# Product Enhancement

## Center Support Modification

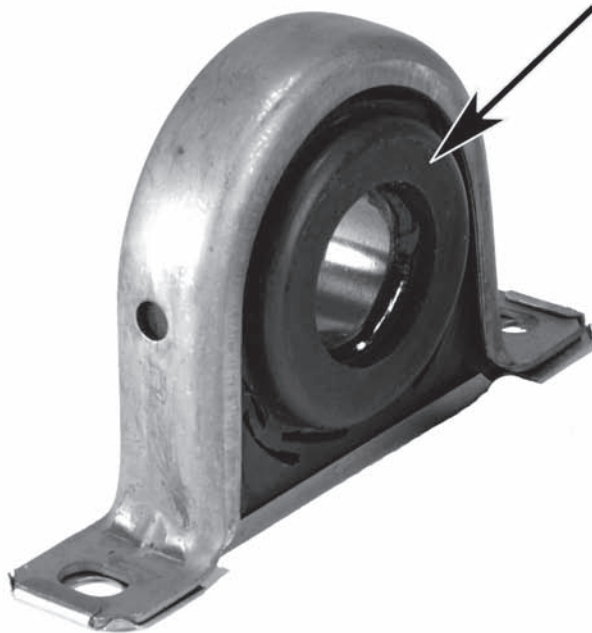
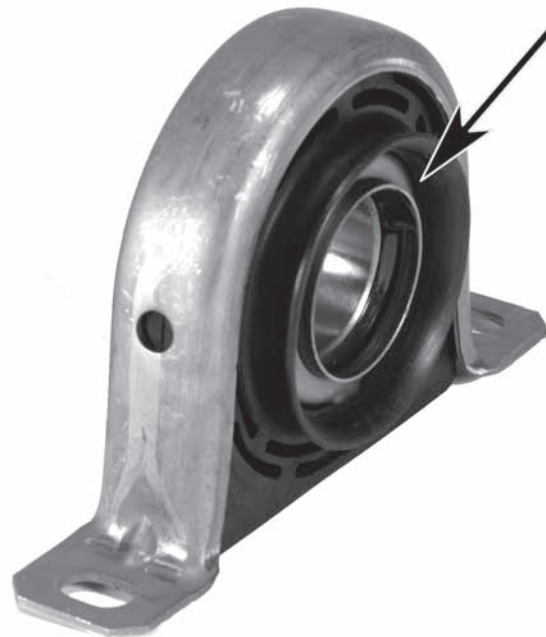
Neapco center support part numbers N211016X, N210866-1X & N210873-1X have been updated to reflect the current OE design. The flared diametrical lip that appears on one side only is now on both sides. This change will eliminate the slinger clearance issues that existed on some applications.
